New Construction for:
Belmont College - Construction Trades Building

Addendum No. 05 – 21.162

August 6, 2025

D5 PLAN DETAIL
SCALE: 1/12" = 1'-0"

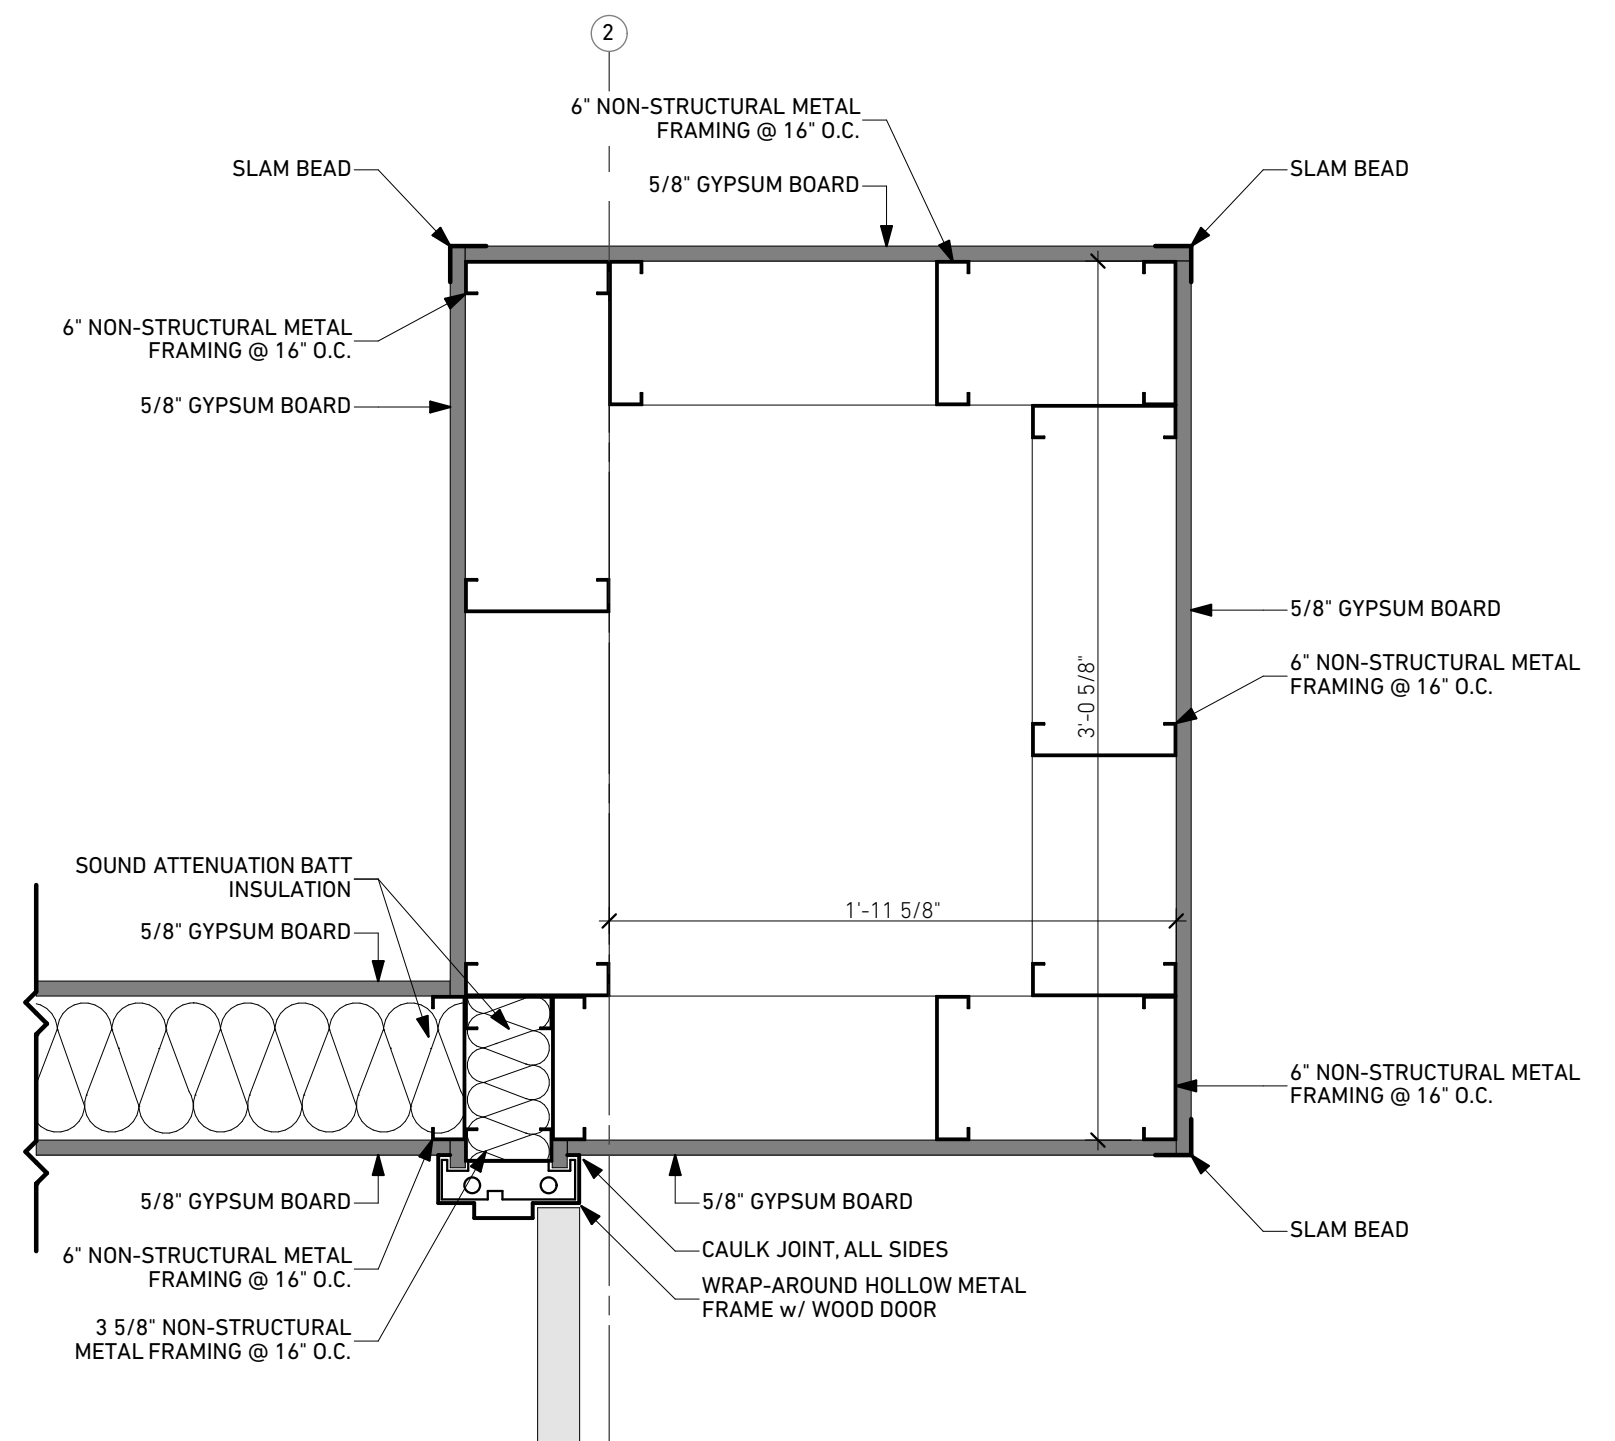
1. Drawing 4,5 – PLAN DETAILS
 - A. Detail D5 revised to show wood blocking.
2. Drawing 7.2 – WALL SECTIONS & DETAILS
 - A. Detail D2 revised to show steel beam spanning large section door opening w/ CMU for sectional door attachment.

FIRST FLOOR PLUMBING PLAN

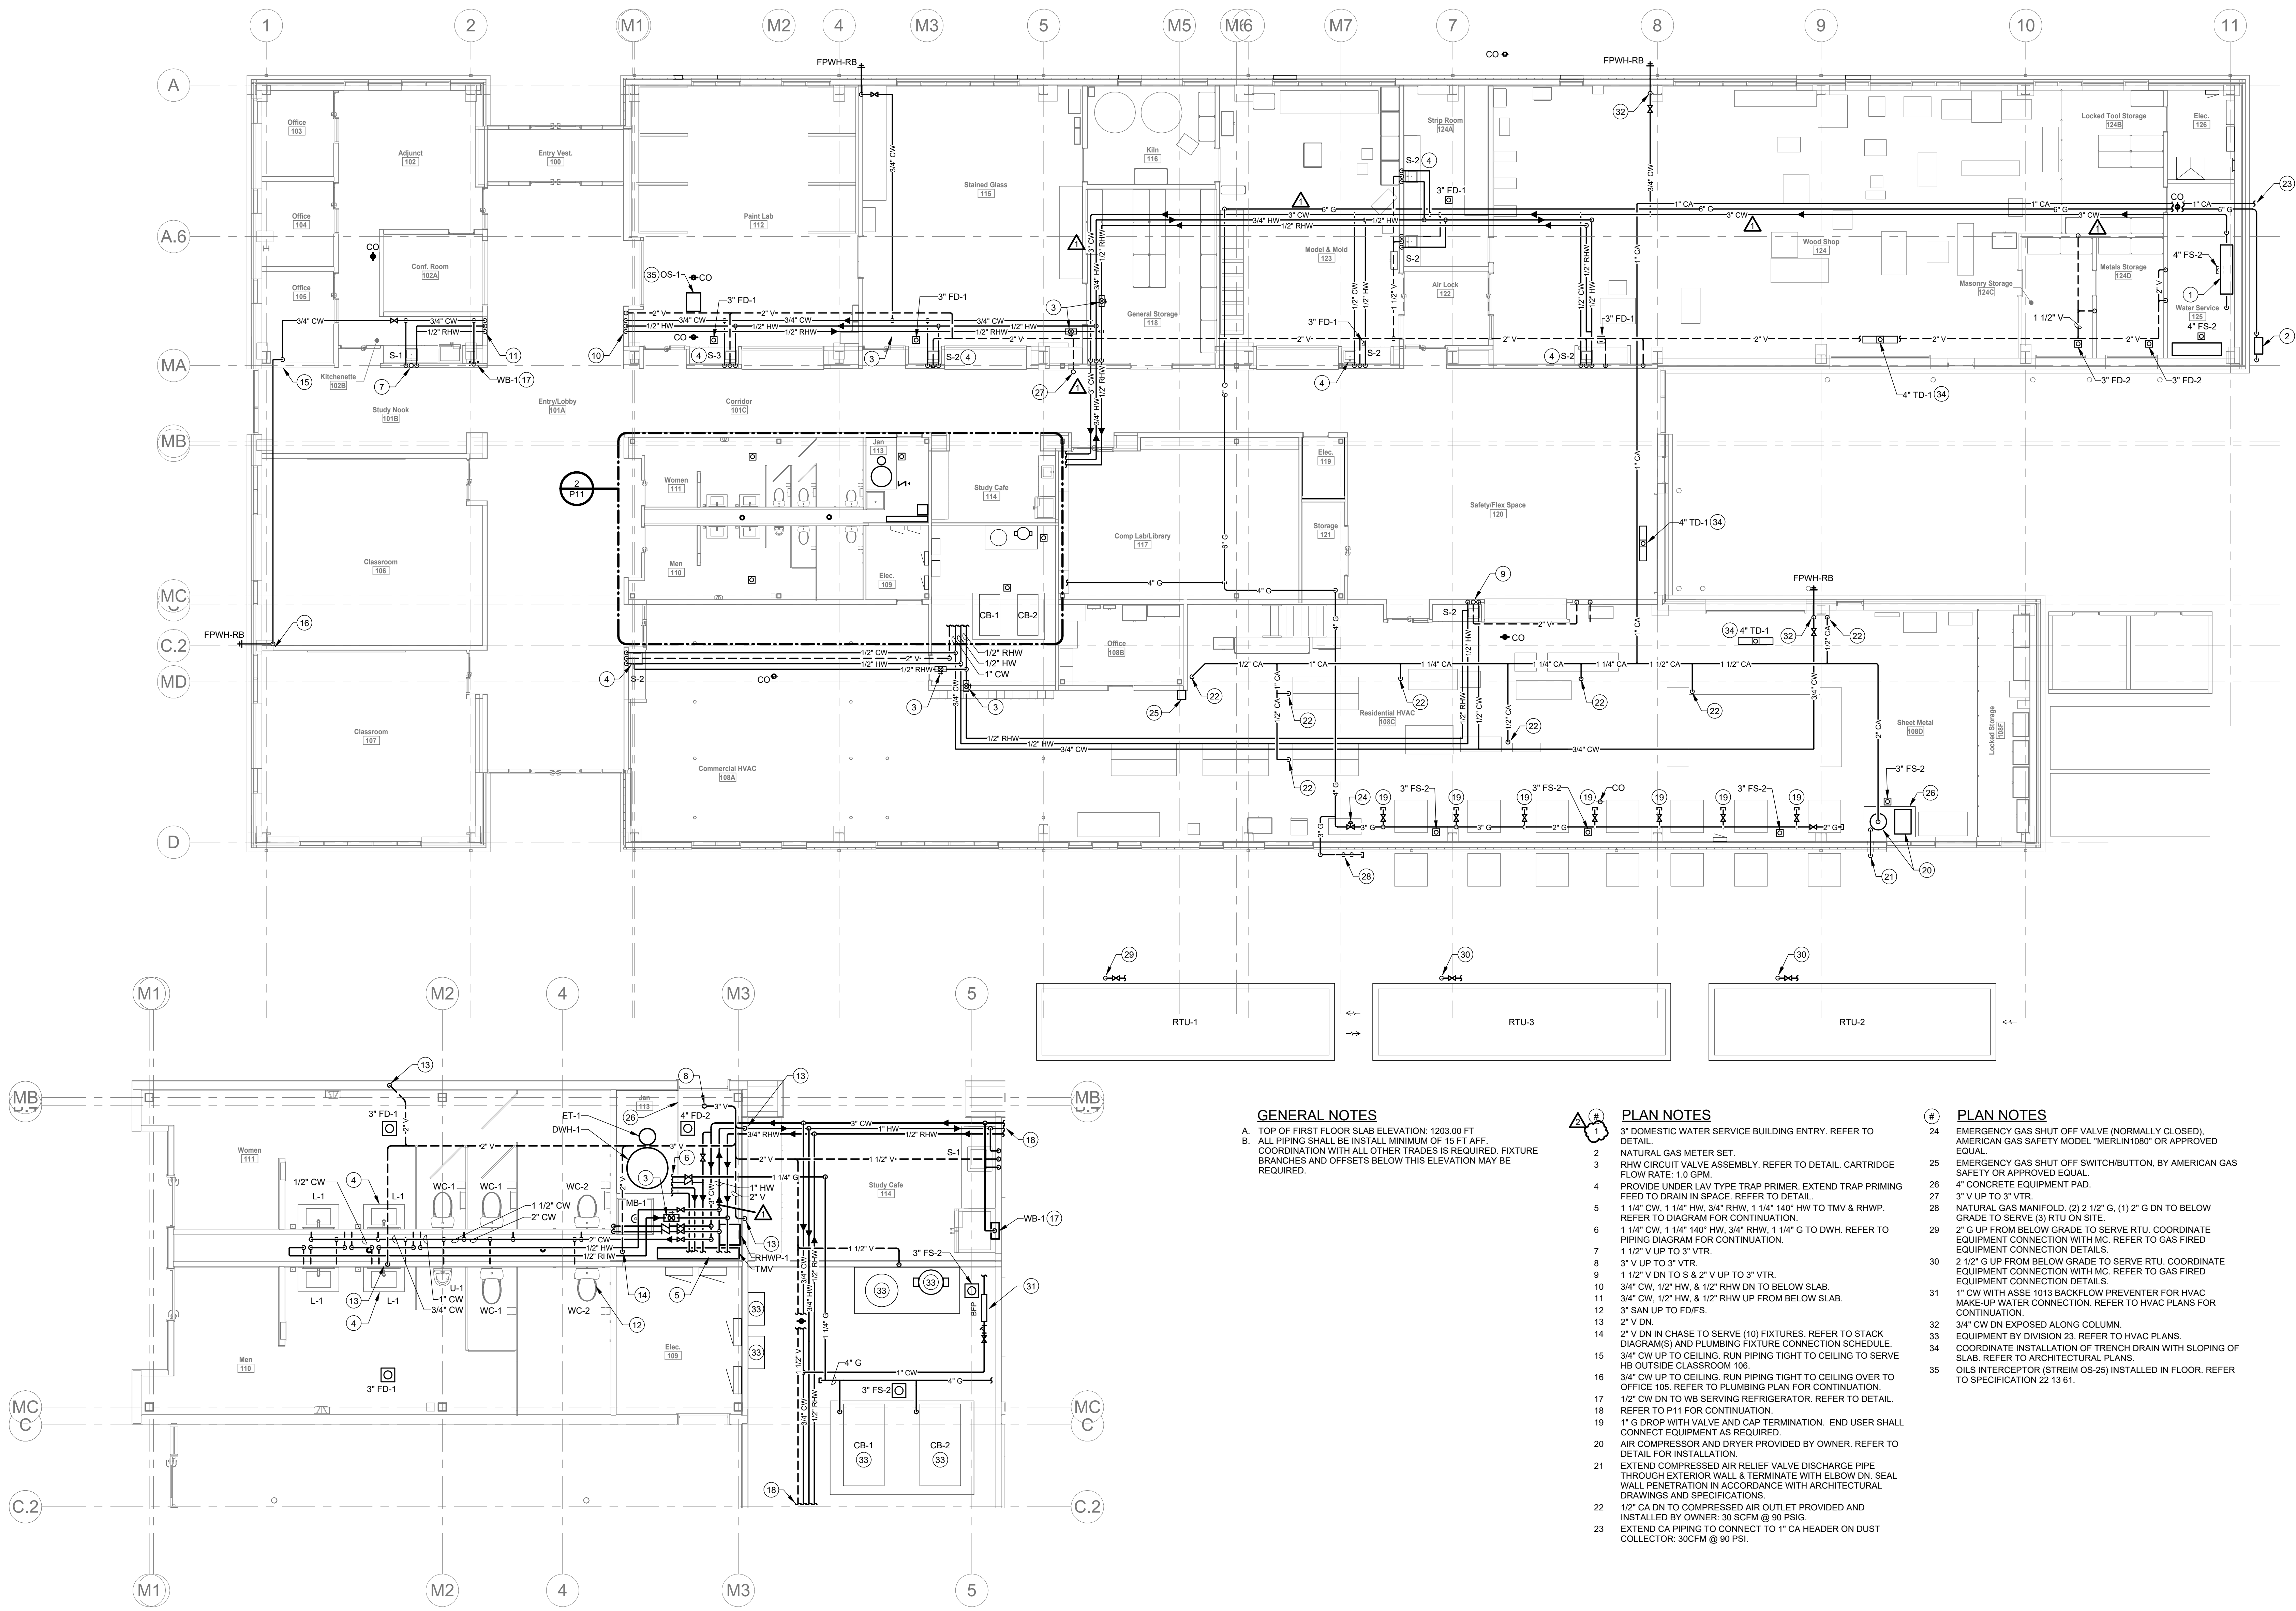
- B. Jamb detail J3 revised to show wood blocking.
2. Drawing FP11 – FIRST FLOOR FIRE PROTECTION PLAN
 - A. Added PIV to Sprinkler Main.
3. Drawing P11 – FIRST FLOOR PLUMBING PLAN

- A. Revised Plan note 1.
 - B. Relocated DWH Check Value to match diagram.
4. Drawing P61 – PLUMBING DETAILS AND DIAGRAMS
 - A. Revised Domestic Water Building Entry Diagram for 3" pipe size.

GAS FIRED WATER HEATER PIPING DIAGRAM - THERMOSTATIC MIXING VALVE
(ONE HEATER - ONE WATER TEMPERATURE)
SCALE: NONE

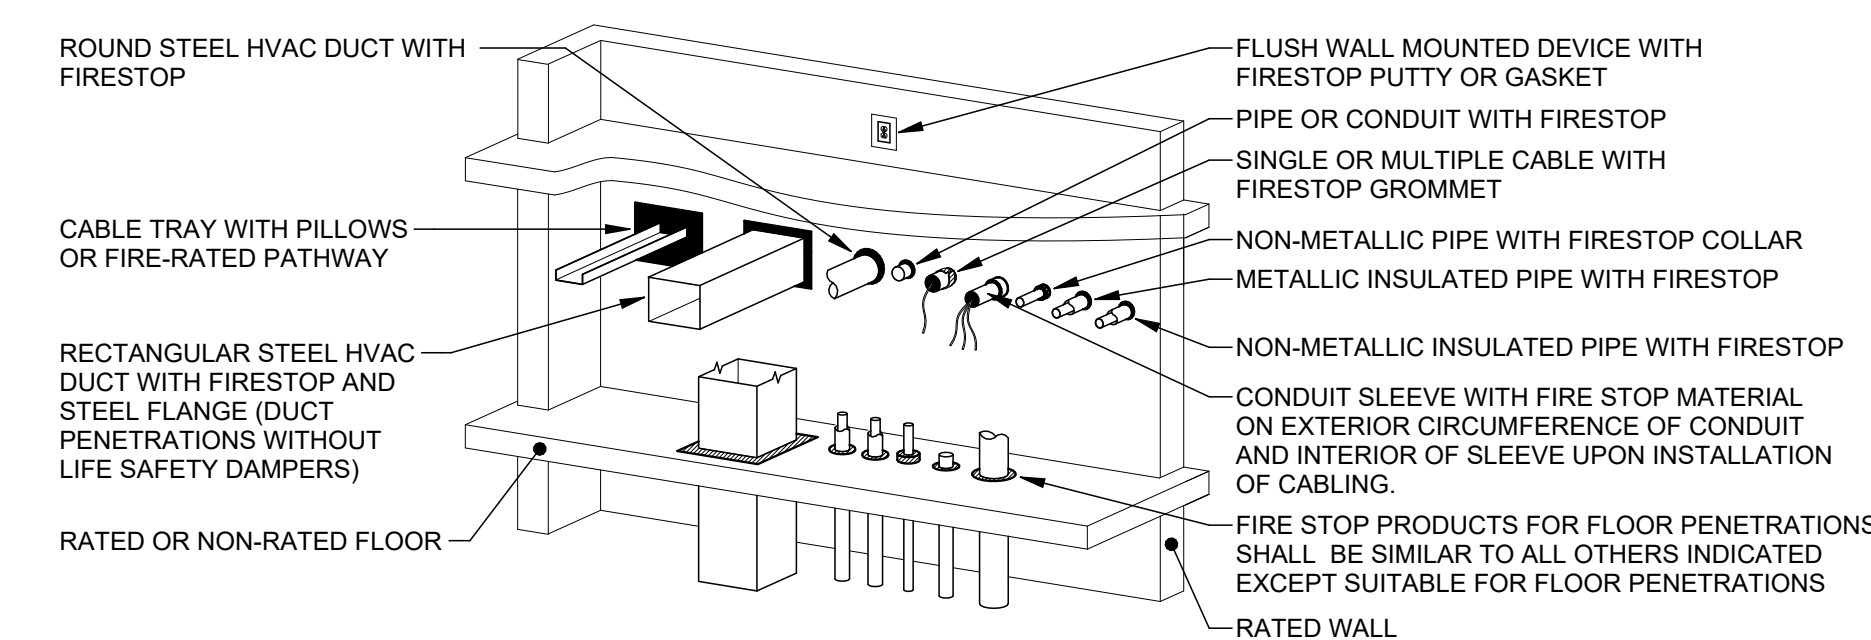
- B. Revised Gas Fired Water Heater Piping Diagram for 1-1/4" CW pipe size to TMV.
5. Drawing C-105 – UTILITY PLAN
 - A. Revised utility plan connections and notation for plumbing connections.
